**ENGINEER'S DAILY REPORT**

04-SF-80-13.2/13.9  
 Contract No. 04-0120F4  
 {SAS Superstructure}

- See attachment #1.
- ❖ **Submittal NO. ABF-SUB-000171 Rev: 0**  
**Subject: Navigation Warning System – Returned Submittal.**
  - Completed my research of the information to correct the submittal package and address the contractor's concerns on the returned submittal package.

Submittal No: 171/10.1

# FA-143079 200 MM BRIDGE LANTERN

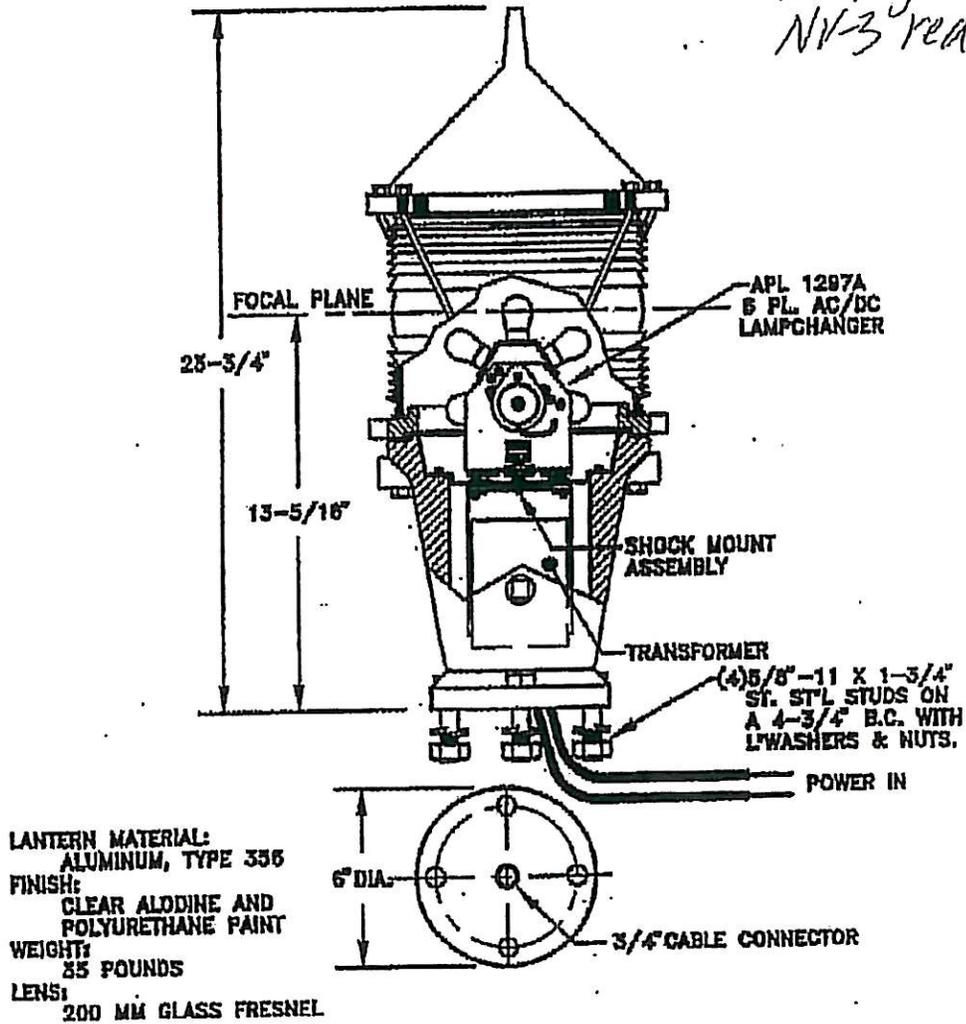
Need to change back to 6 (M.Travis)

Need to remove (M. Travis)
